RE: Planning application: 137226/FO/2023 and 137227/FO/2023

Crown Street – 137226

Plot D – 137227

Reference to Figure 4 - as of August 2025

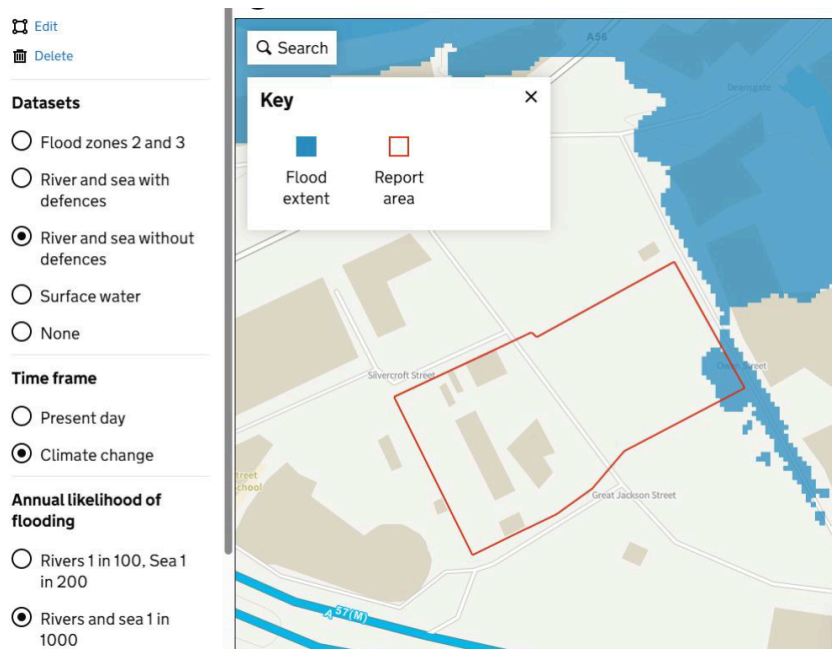
There is a small area of land to Owen Street / Melbourne Street corner of Plot E2 that has a chance of 1% AEP + CC.

At the time of writing the addendum report (August 2025), it was noted on the EA mapping that there could be a 1 in 1000-year (0.1%) chance that a small portion of the site (namely the corner of Plot E2) could be impacted by fluvial flooding during defended and undefended scenarios for the period between 2070 and 2125. (As demonstrated in Figure 4 of the report – and extracted below).

The applicant could update the FRA with the FFL details and details of property flood resilience measures. We could then mark the FRA as an approved document and that the proposal should be constructed in accordance with the FFL recommendations in the Flood Risk Assessment. Otherwise we can amend the wording to:

b) “Details of Finished Floor Levels set in accordance with Standing Advice, a minimum of 300mm above the estimated flood level for the 1% AEP + Climate Change allowance event. Where FFLs cannot be raised, PFR can be proposed. PFR measures must protect to a minimum of 600mm above the estimated flood level.”

Updated Mapping as of September 2025

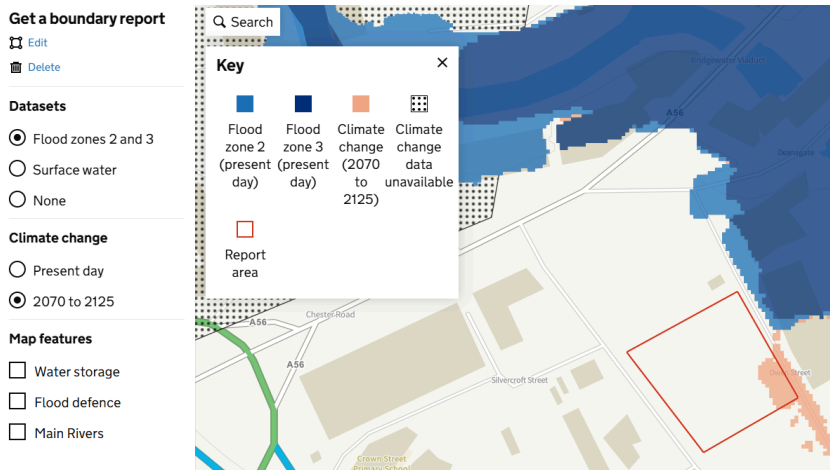
The latest mapping (update in September 2025) with climate change extents shown in orange (as shown in the mapping below) now only confirms how the combined extent of flood zones 2 and 3 could increase with climate change over the next century, which means only the full extent of the 1 in 100 and 1 in 1000 year risk plus climate change risks can be seen, which doesn't provide the 1 in 100 year plus climate change risk alone.

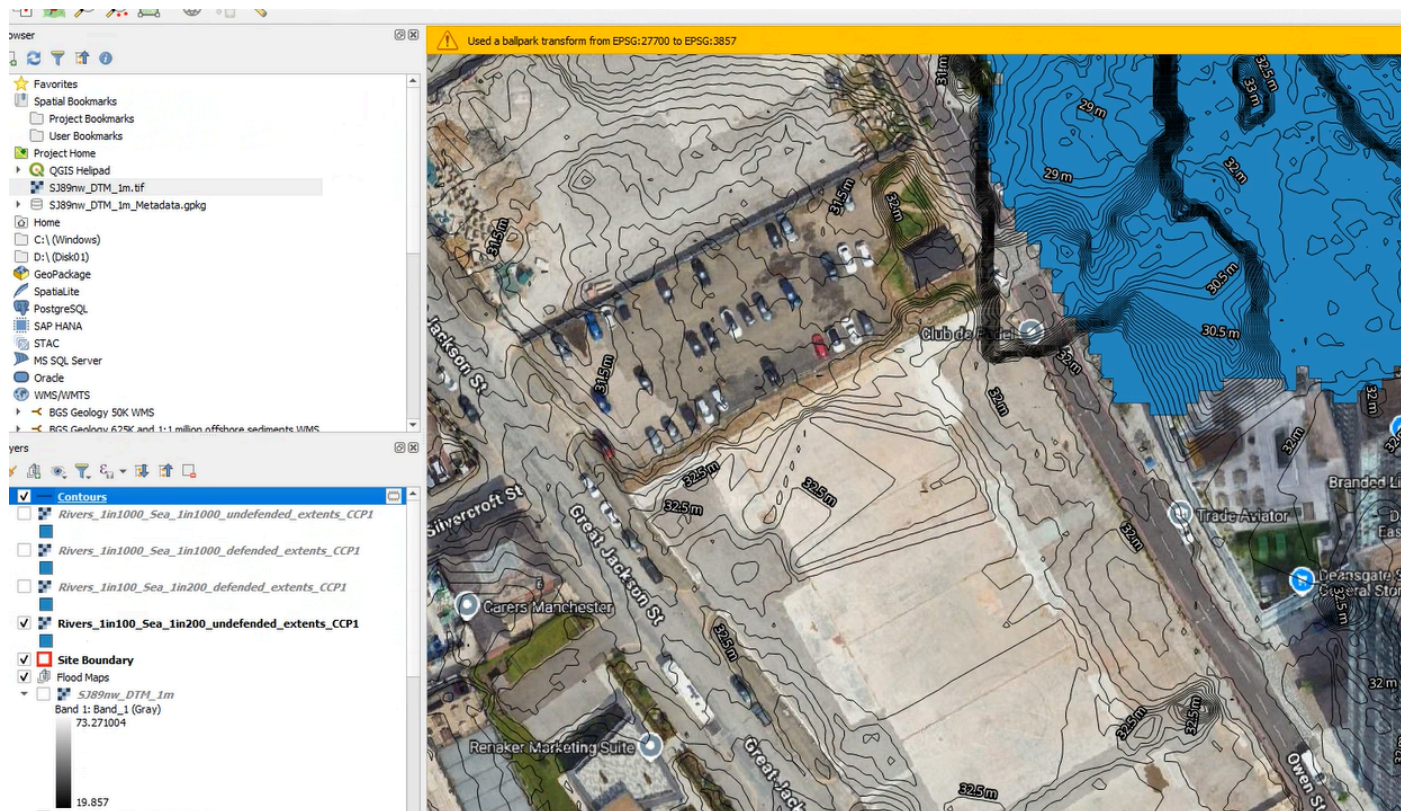
To ascertain the predicted flood level at the **1in 100 year +cc** projected extents Curtin's has downloaded the available LiDAR data and flood extents data from the government website, which is dated 27/08/2025 (overlay extract below). This indicates that the expected flood water extends to a level between **31.5-31.9m**. However, the Lidar data doesn't appear to be completely up to date around Deansgate Square and the flood extents don't align with a consistent contour line.

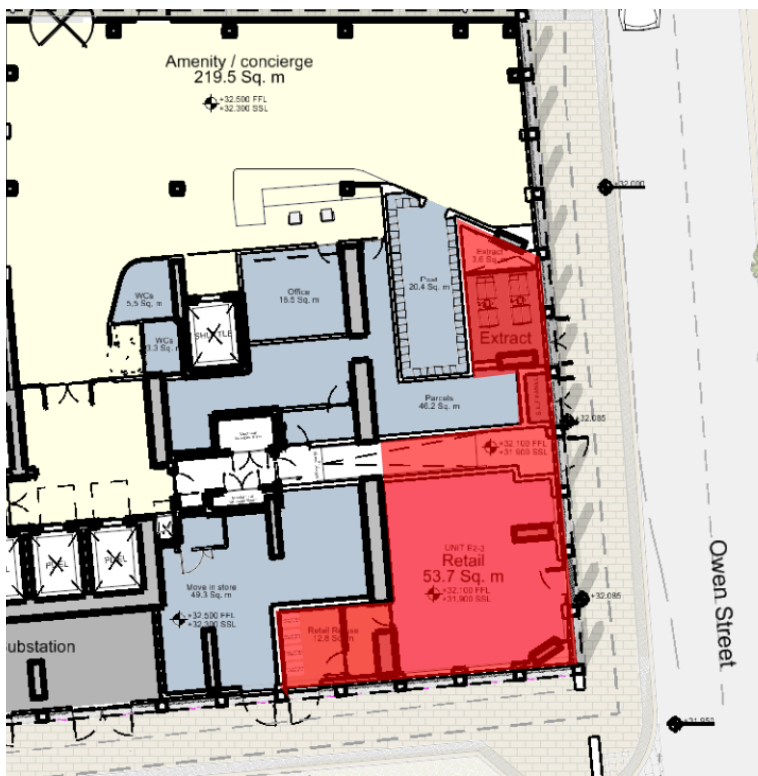
The area highlighted in red on the proposed floor plan below has a FFL of 32.100m, all other areas are at a FFL of 32.500m. Taking the worst-case position, the FFL at 32.1mm would be 200mm above the highest flood level of 31.9m.

The FFL cannot be amended as it needs to tie into the existing levels at Owen Street.

The area in question represents a small part of the site and is proposed for a less vulnerable use (Retail) and plant that can be accommodated above the 300mm flood level. It is therefore proposed that the wording of the condition is amended to provide sufficient flexibility to allow for resilient construction practices to be included (such as ensuring all electricals / plant etc are at least 300mm above the flood level) and for an emergency plan to be in place in the event of any flooding.

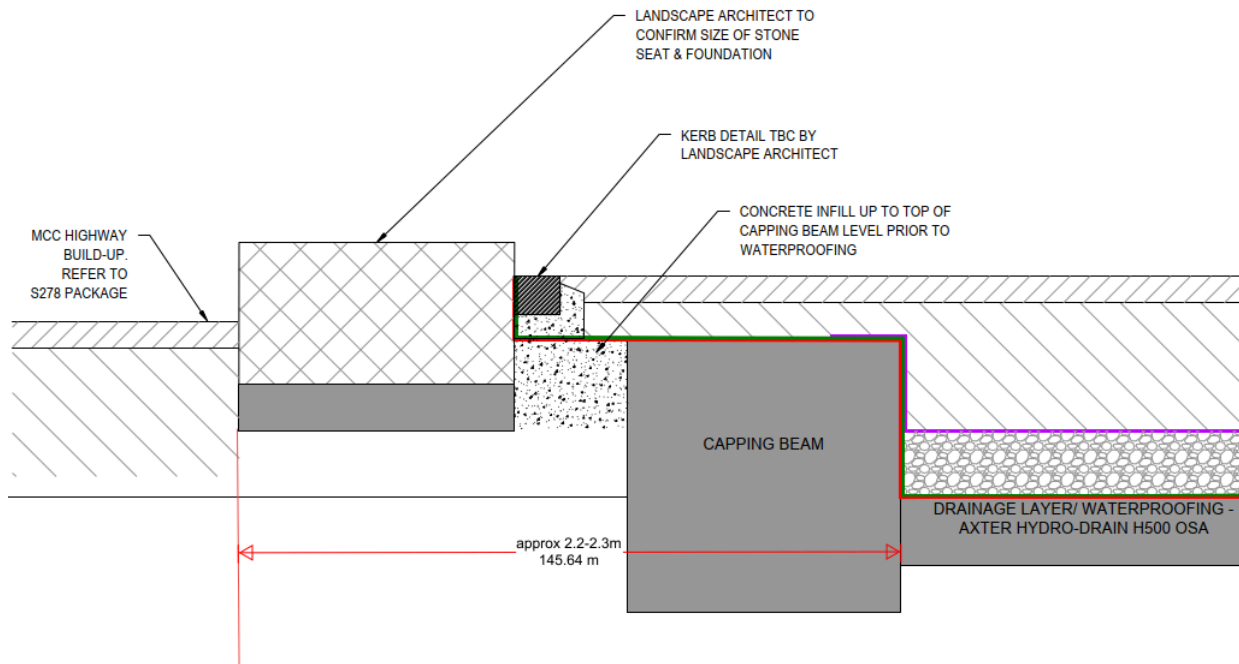
e) Where a public sewer diversion or abandonment is required, an agreement in principle from United Utilities is required. An email of acceptance will suffice.

f) Where a public sewer diversion, abandonment or build-over is proposed, agreement in principle from United Utilities is required. An email of acceptance will suffice.

E and f to be removed – there are no public sewers, therefore not applicable.

e) & f) – On further review, the mapped sewer on site is shown as privately owned rather than public sewer. Happy for these two clauses to therefore be removed.
